APPLICATION NO.	FILING DATE	FIRST NAMED INVENTOR	ATTORNEY DOCKET NO.	CONFIRMATION NO.
10/765,583	01/27/2004	Thomas L. Toth	GEMS8081.196	1715

Office Action Summary	Application No.	Applicant(s)	
	10/765,583	TOTH ET AL.	
	Examiner	Art Unit	
	Chih-Cheng Glen Kao	2882

TITLE: SYSTEM AND METHOD OF DETERMINING A CENTER OF MASS OF AN IMAGING SUBJECT FOR X-RAY FLUX MANAGEMENT CONTROL

FIG. 18

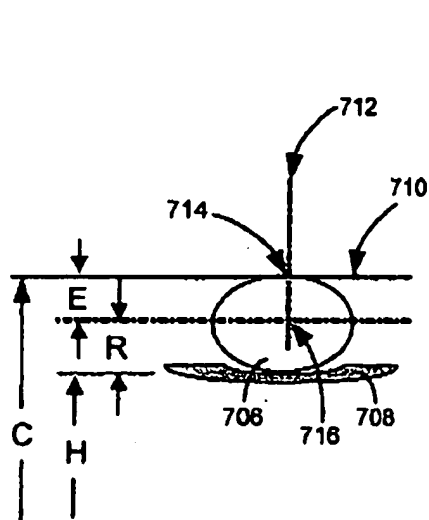
1. The drawings are objected to because of the following: (equation “ $E=R+H-C$ ” not corresponding to fig. 18) and (equation “ $E=C-R-L$ ” not corresponding to fig. 19). The equation “ $E=R+H-C$ ” is equivalent to $E+C=R+H$. However, as seen in Figure 18, $E+C$ does not equal $R+H$. Likewise, the equation “ $E=C-R-L$ ” is equivalent to $E+R+L=C$. However, as seen in Figure 19, $E+R+L$ does not equal C .

Corrected drawing sheets in compliance with 37 CFR 1.121(d), or amendment to the specification to add the reference character(s) in the description in compliance with 37 CFR 1.121(b) are required in reply to the Office action to avoid abandonment of the application. Any amended replacement drawing sheet should include all of the figures appearing on the immediate prior version of the sheet, even if only one figure is being amended. Each drawing sheet submitted after the filing date of an application must be labeled in the top margin as either “Replacement Sheet” or “New Sheet” pursuant to 37 CFR 1.121(d). If the changes are not accepted by the examiner, the applicant will be notified and informed of any required corrective action in the next Office action. The objection to the drawings will not be held in abeyance.
